#### **BOARD ACTION REPORT – APPEALABLE ITEM**

Project Name: 20 Lake Court Project Location: 20 Lake Court

Request: Certificate of Appropriateness Board: Historic Preservation Board

# HISTORIC PRESERVATION BOARD CITY OF DELRAY BEACH ---STAFF REPORT---

DRAWN B	Y BDF			
CHECKED BY				
DATE	1-11-17			
SCALE	AS NOTED			
JOB NO.	14116.07			
SHEET				
1

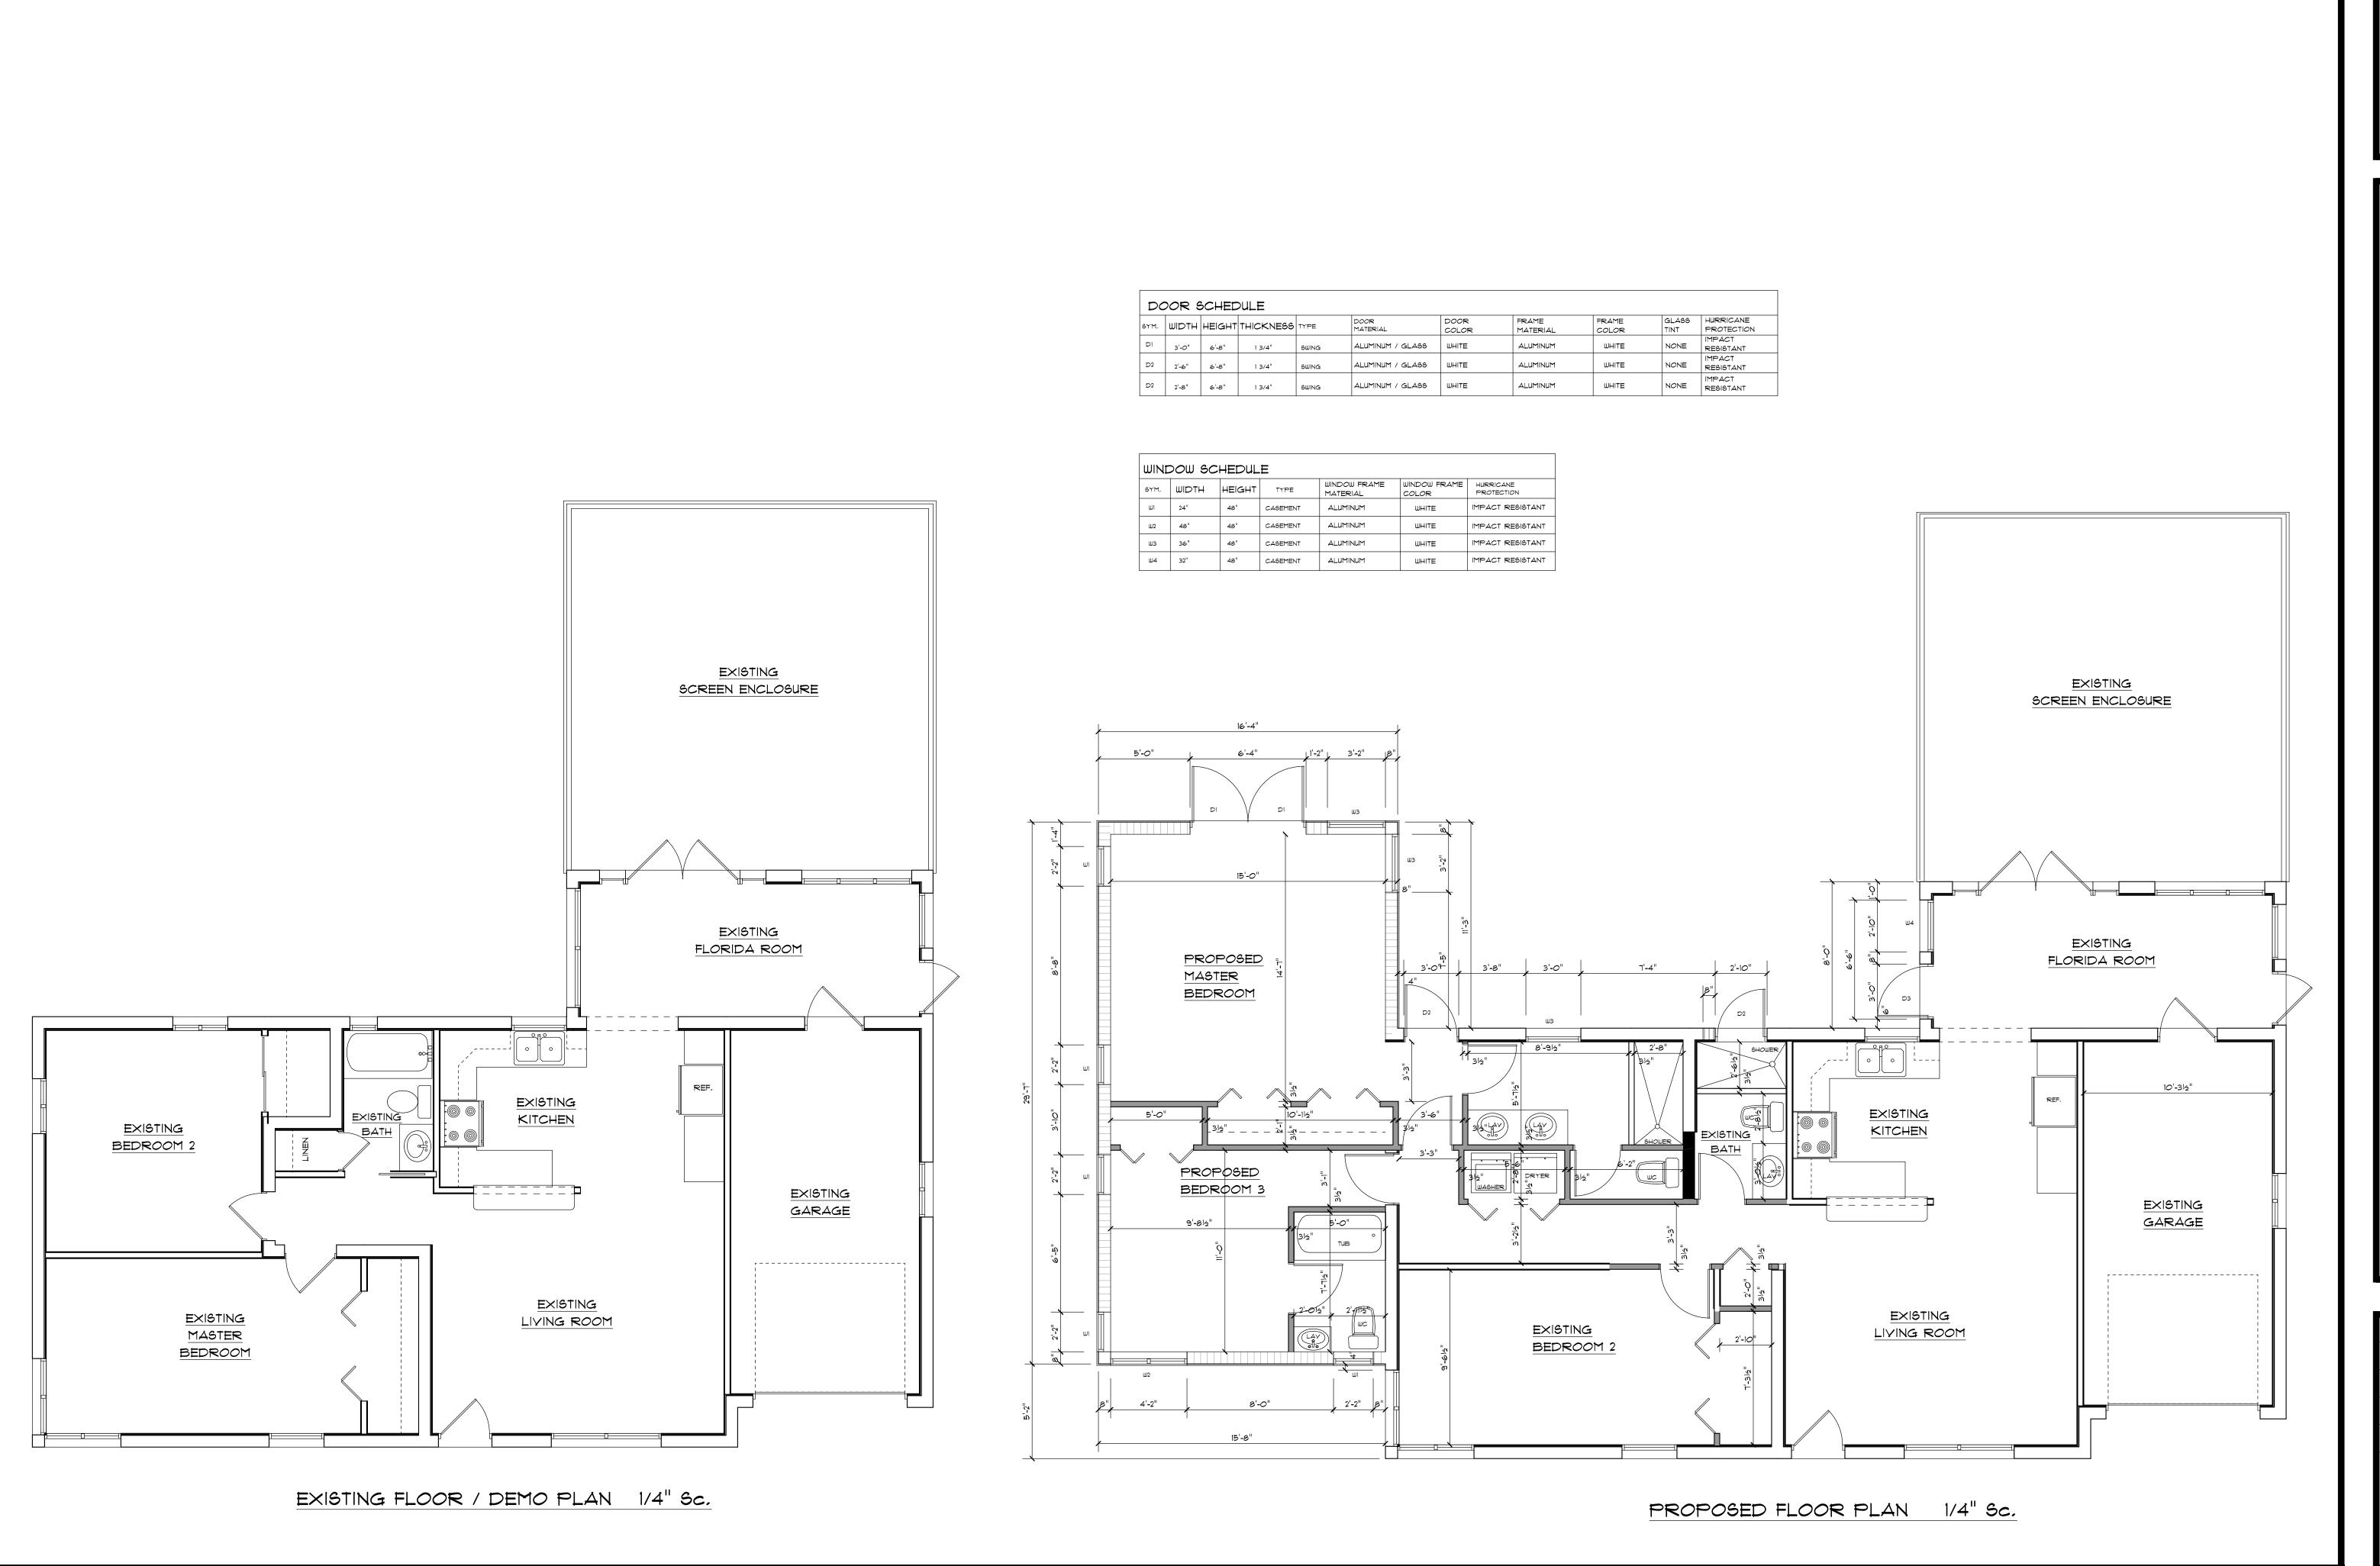
The Board comments were supportive. The Board added one (1) condition of approval that the applicant remove the note referencing P.V.C. fence from the site plan.

It is noted that the development plans indicate removal of some of the original brick planters, the applicant/home owner has noted that such removal is not planned and they are to be retained. A condition of approval has been included to update the plans to indicate the brick planters. Otherwise, removal of the planters would question compliance with Standards 2, 9 and 10.

It is noted that the proposed windows are not true divided light windows and the plans do not delineate what type of muntins are to be utilized; thus, dimensional muntins must be applied to the exterior of the glass. Thus, this item has been added as a condition of approval.

- 1. That all existing brick planters be retained;
- 2. That the side setback for the new driveway be provided on all associated plans;
- 3. That dimensional muntins be provided on all new casement windows; and,
- 4. That additional revisions may be approved administratively and/or reviewed by the Board, per Staff's direction.
